# Road Safety Audit Review

Ferry Road, Charlotte

July 23, 2020

Vermont Agency of Transportation  
Operations & Safety Bureau

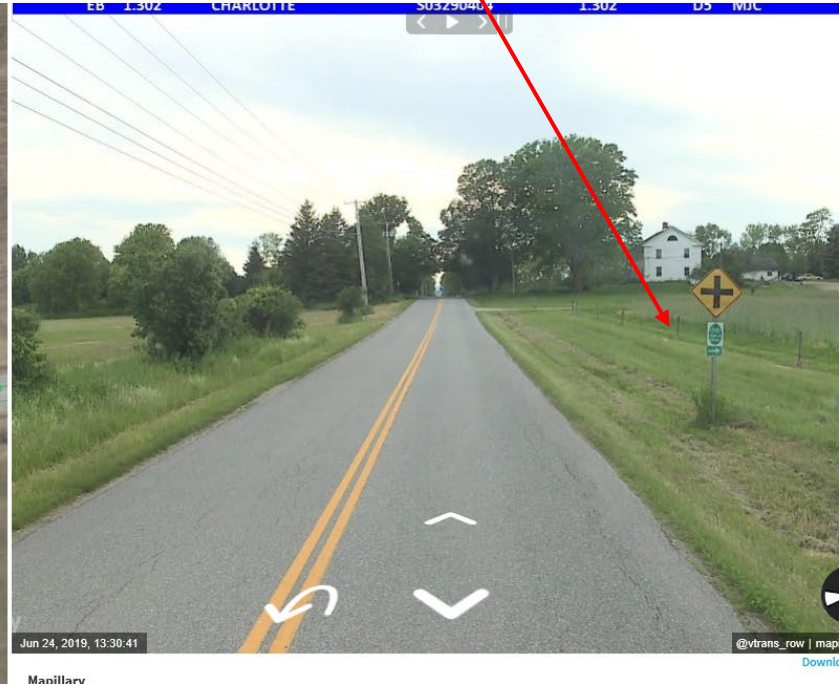
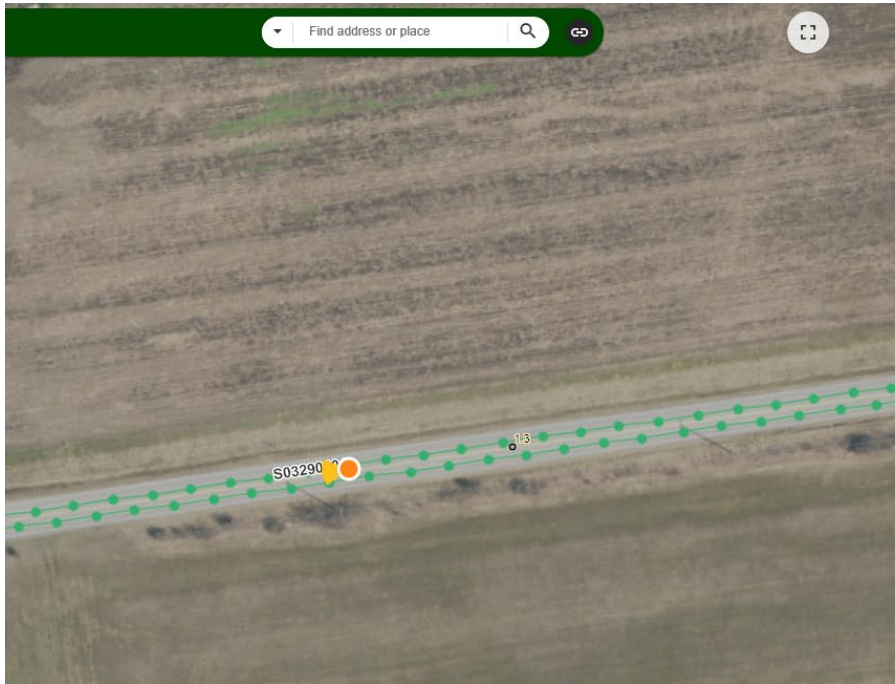
Remove the existing intersection sign for westbound Lake Rd intersection.

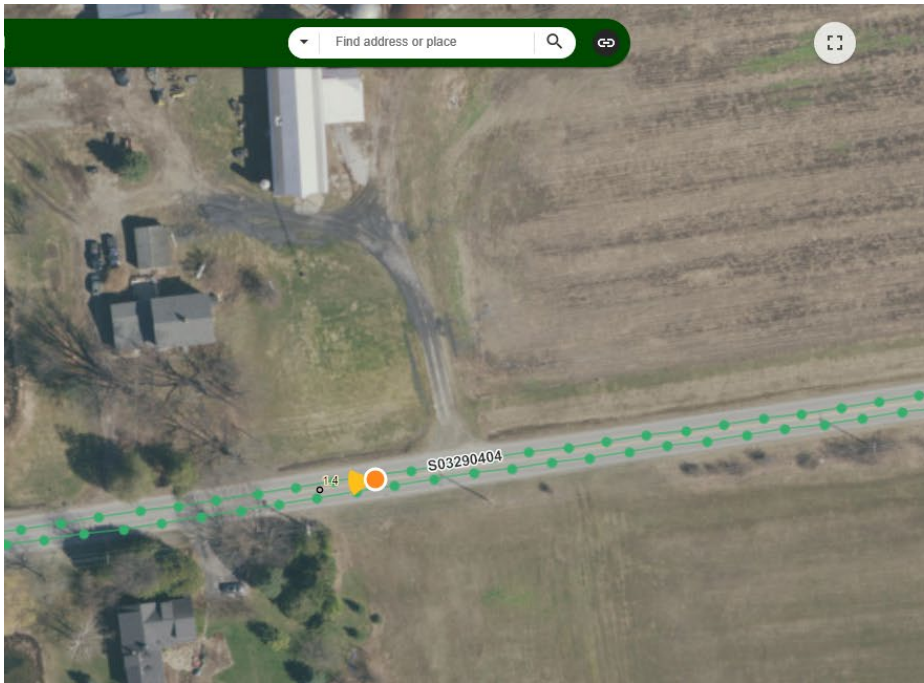
Install an intersection sign (W2-1) with a Lake Rd street name plaque (W16-8P) about 300 ft east of Lake Rd.

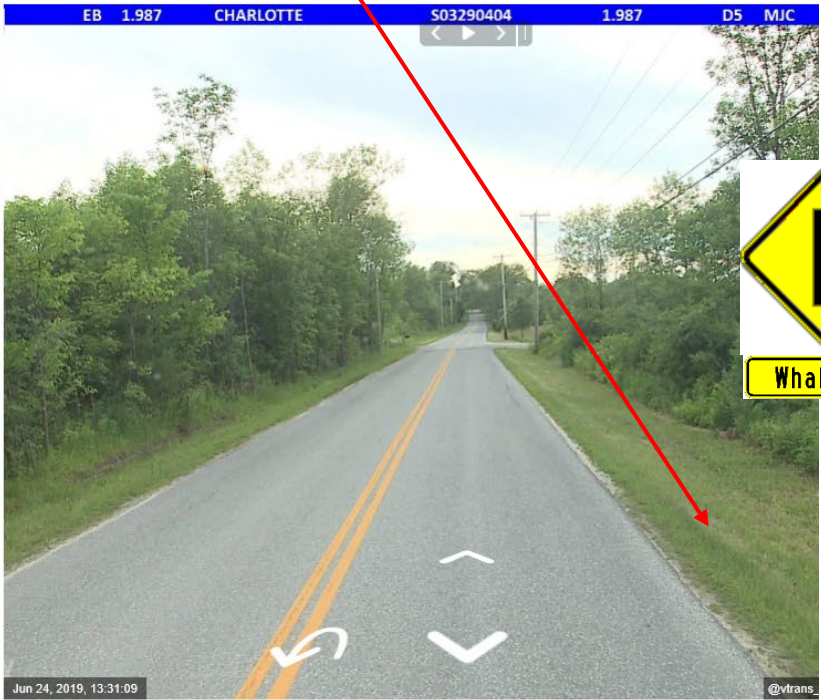
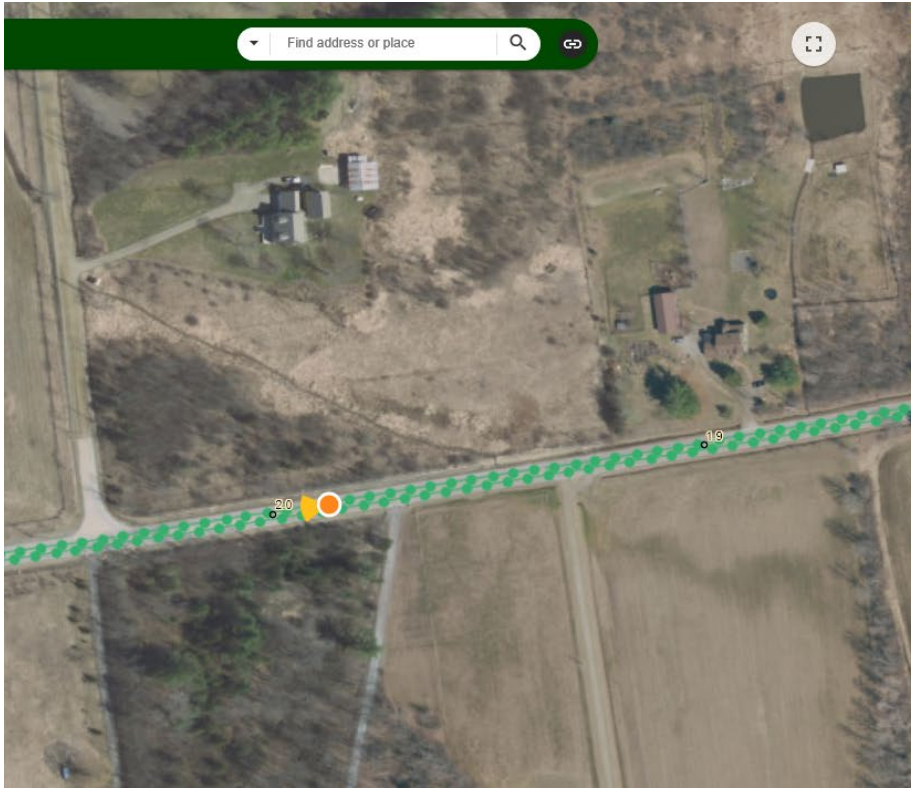
Install a side road intersection sign (W2-2) with a Whalley Rd street name plaque (W16-8P) 300 ft east of Whalley Rd.

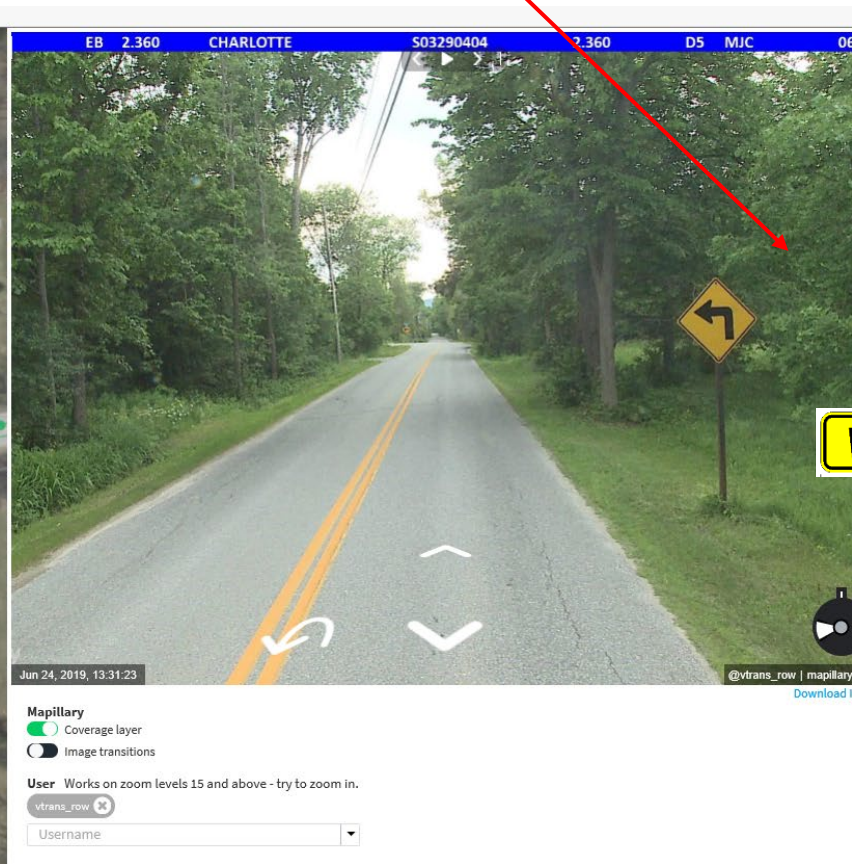
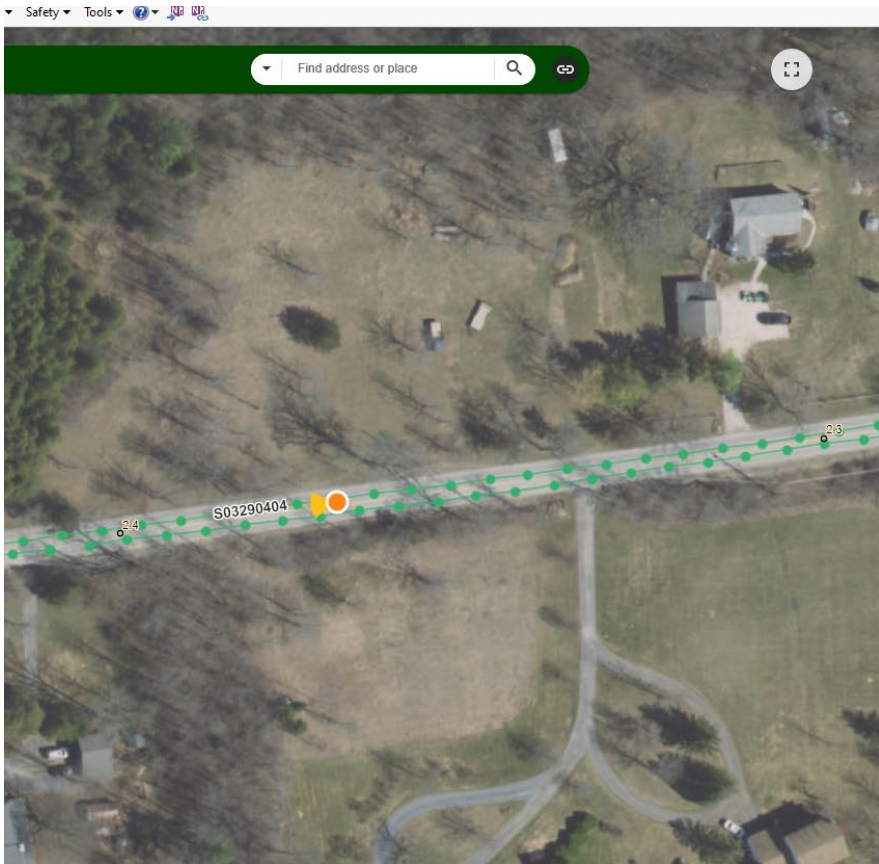
Replace the turn sign with a modified turn sign with a side road up and a 15 mph advisory speed plaque (13-1P), and a Wings Point Rd street name plaque (W16-8P).

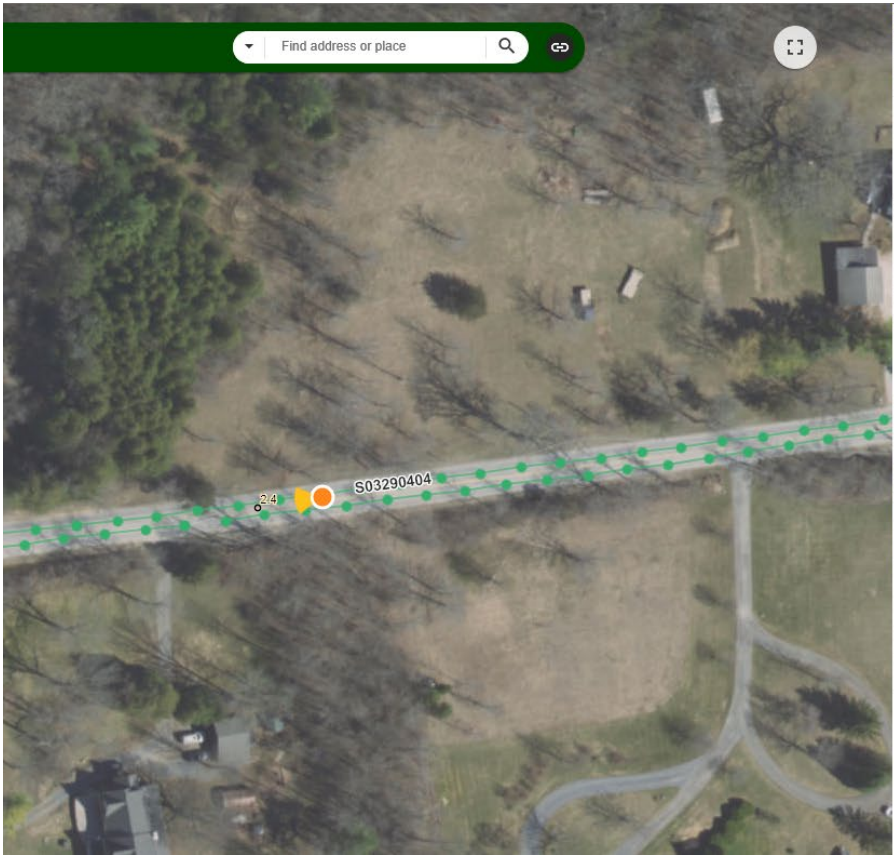
Install a Ferry destination sign (VD1-1) on two posts here.

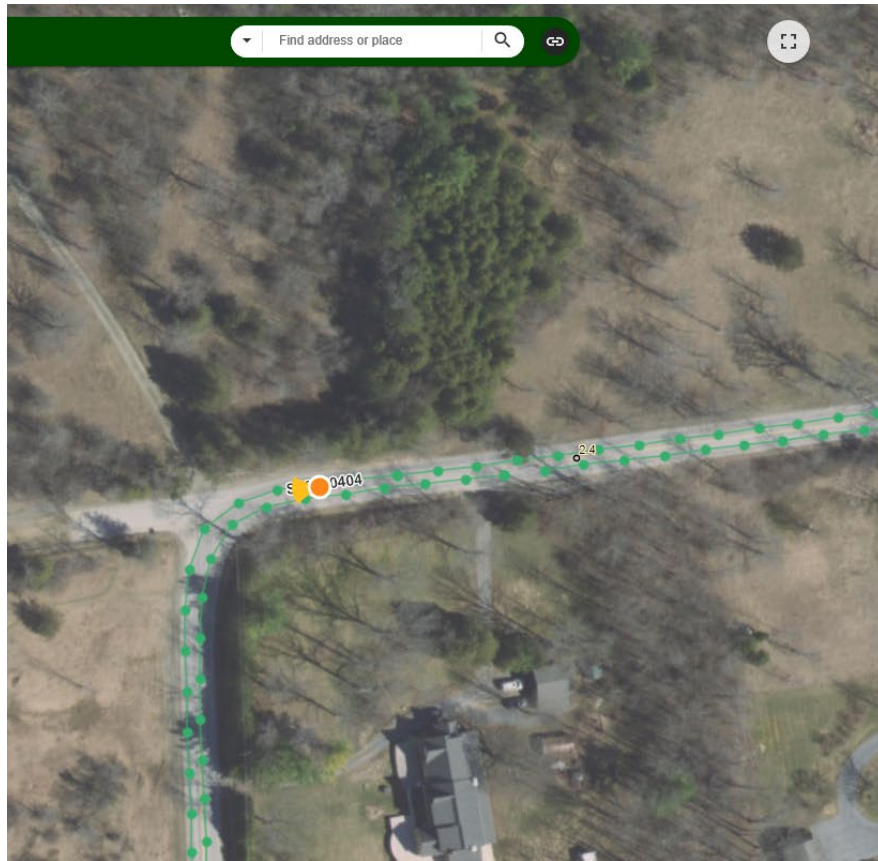
At Wings Point Rd, remove the large arrow and the small yellow ferry sign.

Install a new large arrow (W1-6) here.

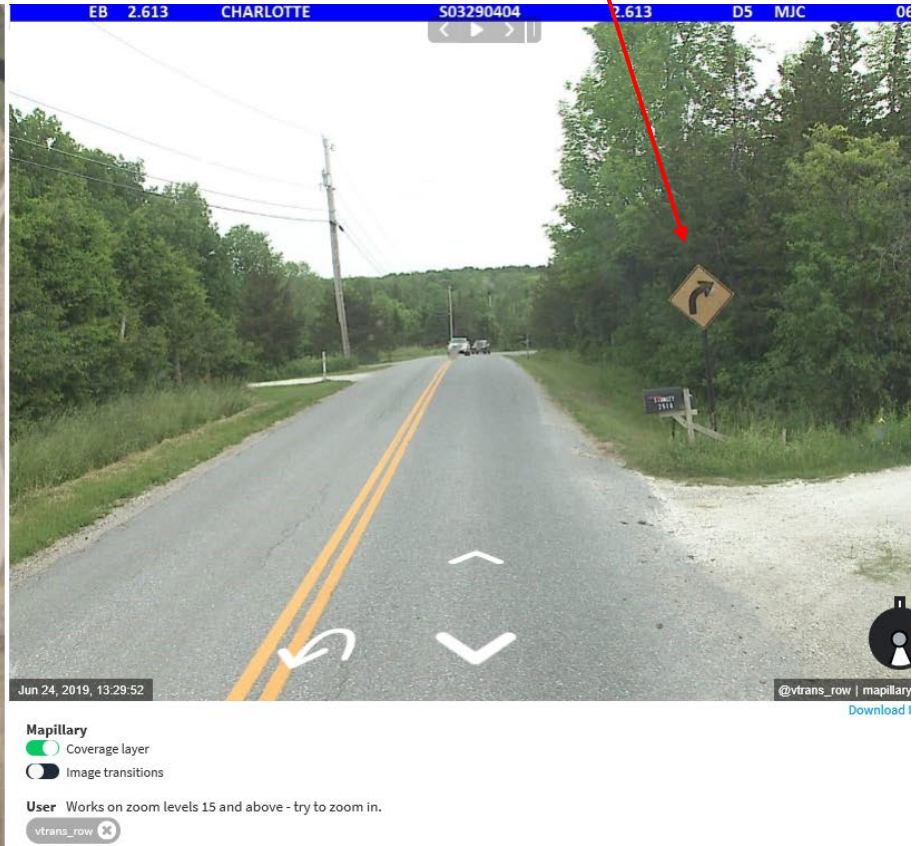
Replace the existing curve sign (W1-2) by mailbox #2518.

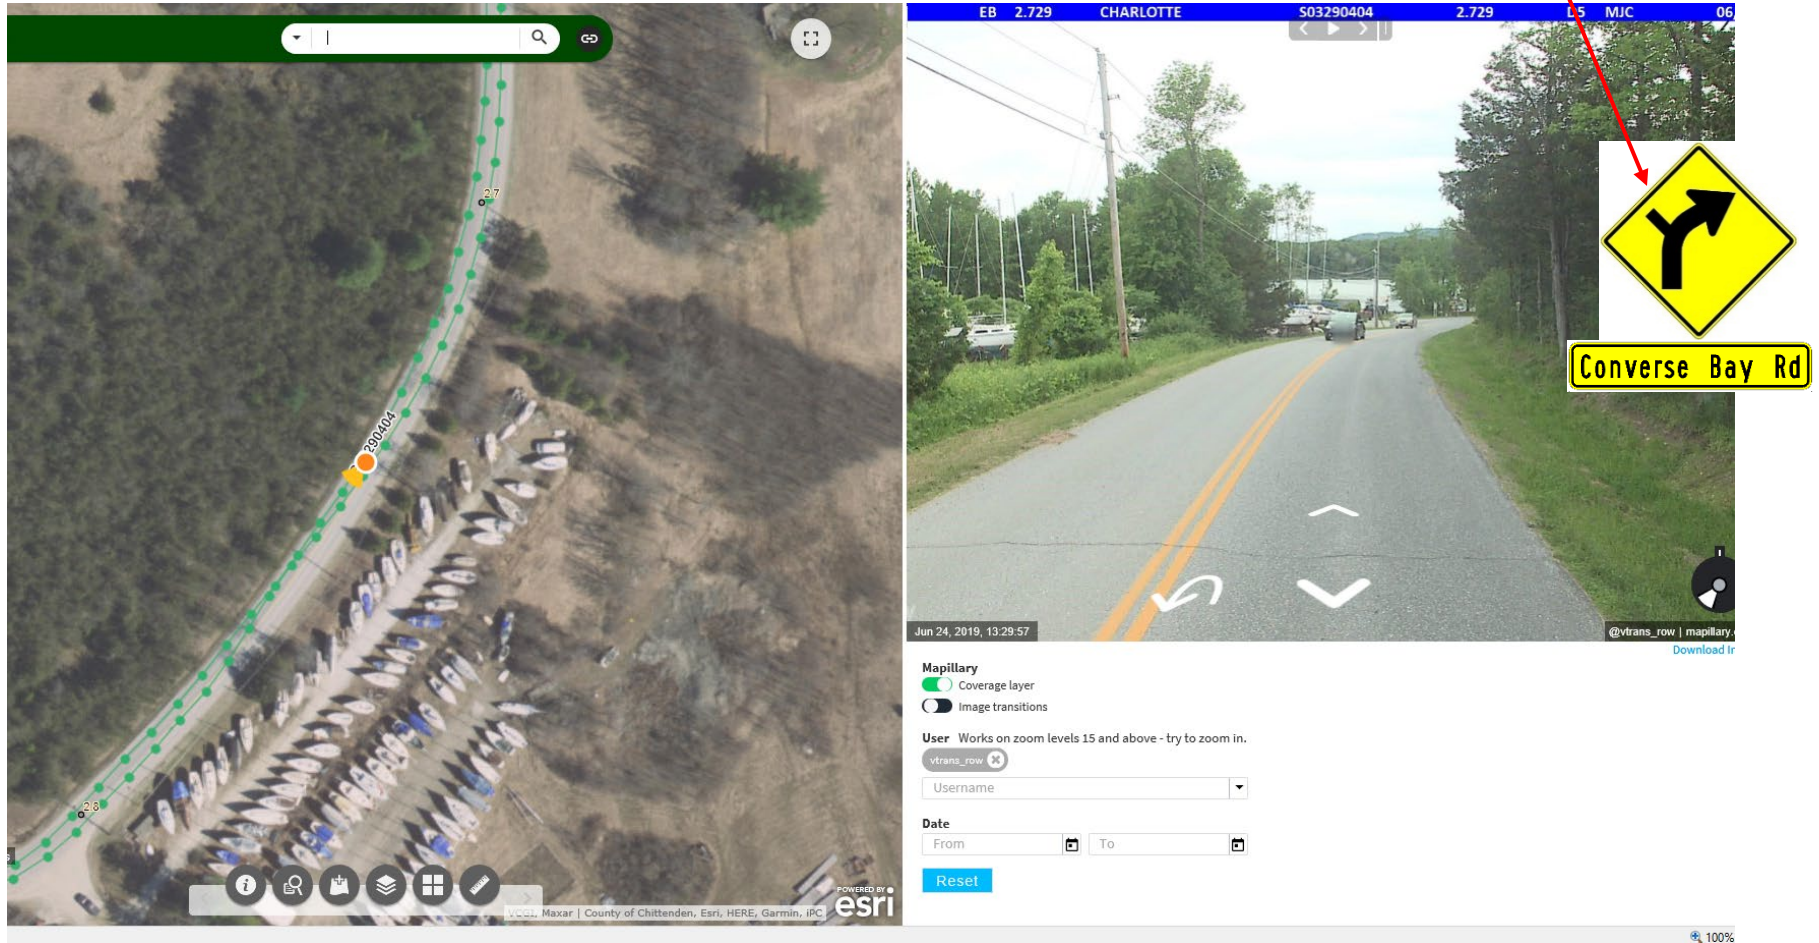
New curve sign with side road (W1-10) and Converse Bay Rd street name plaque (W16-8P). Approximately 150 east of new Ferry Rd destination sign or if chose not to install the Ferry Rd destination sign, 200 ft east of Converse Bay Rd. Install on two posts.

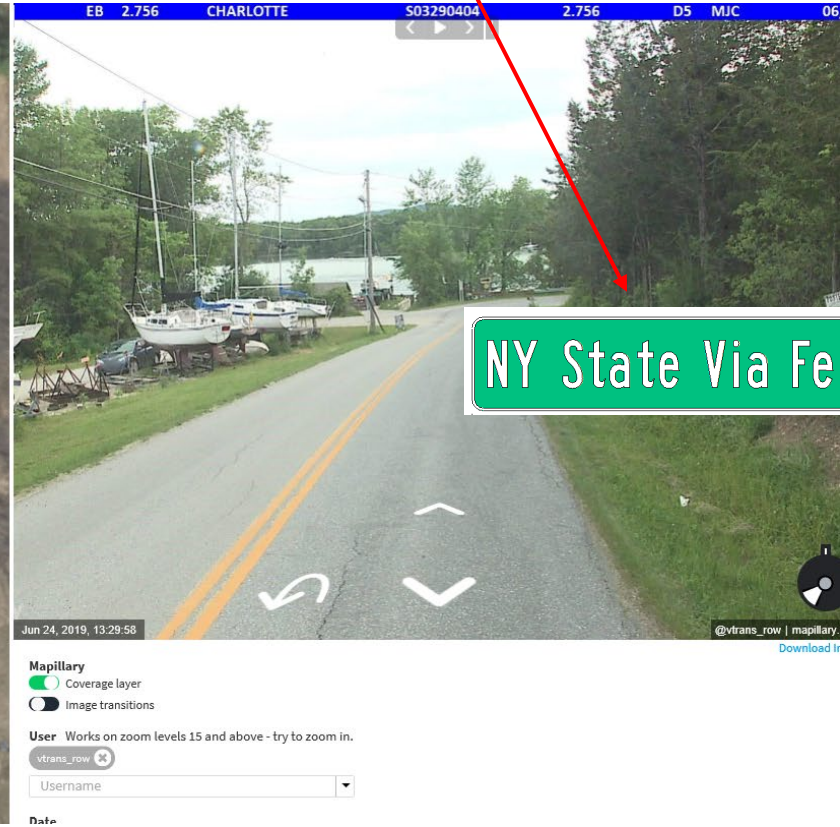
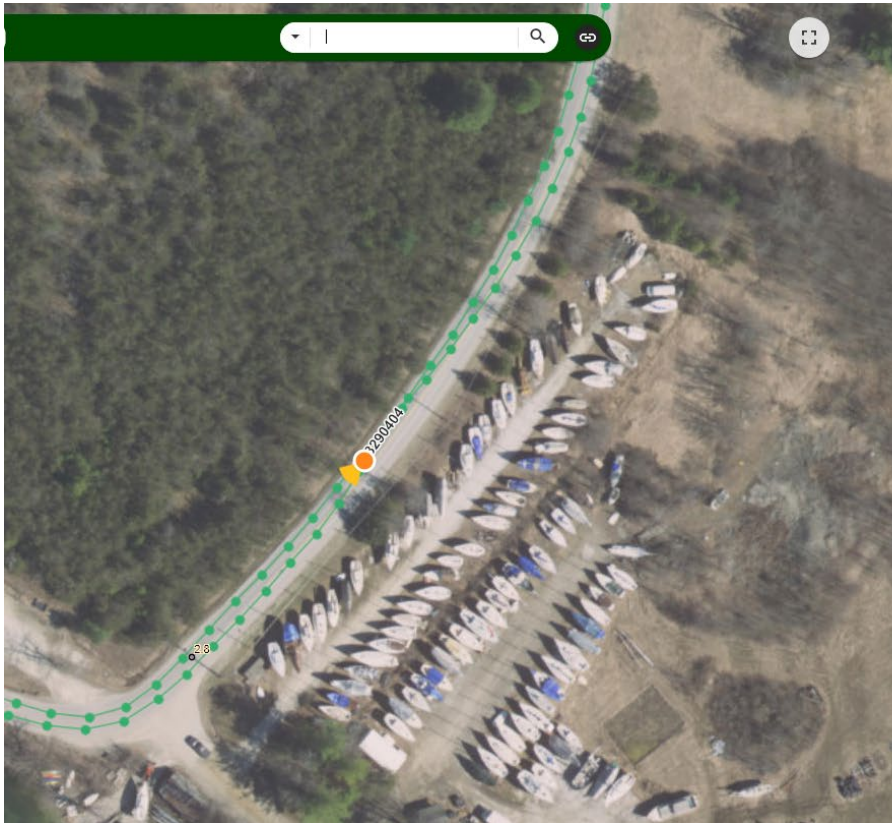
New Ferry destination sign (VD1-1). Approximately 200 ft east of Converse Bay Rd. Install on two posts.

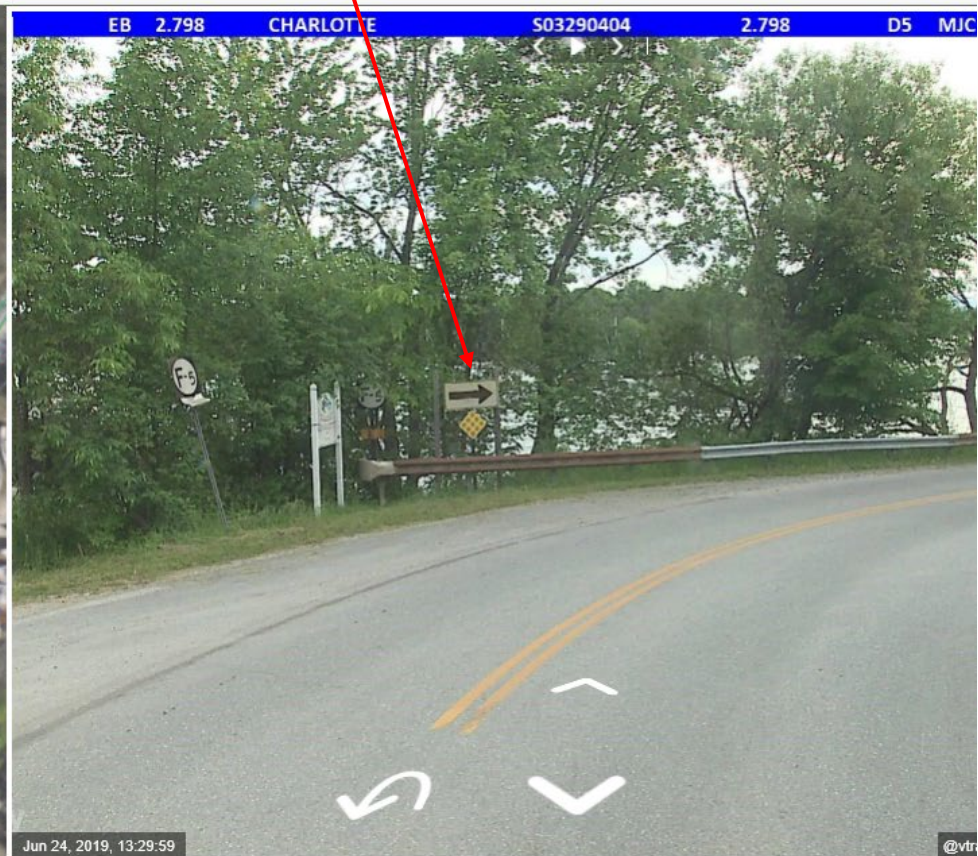
Remove the diamond object marker. Replace the existing large arrow with a new large arrow (W1-6). Install on two posts.
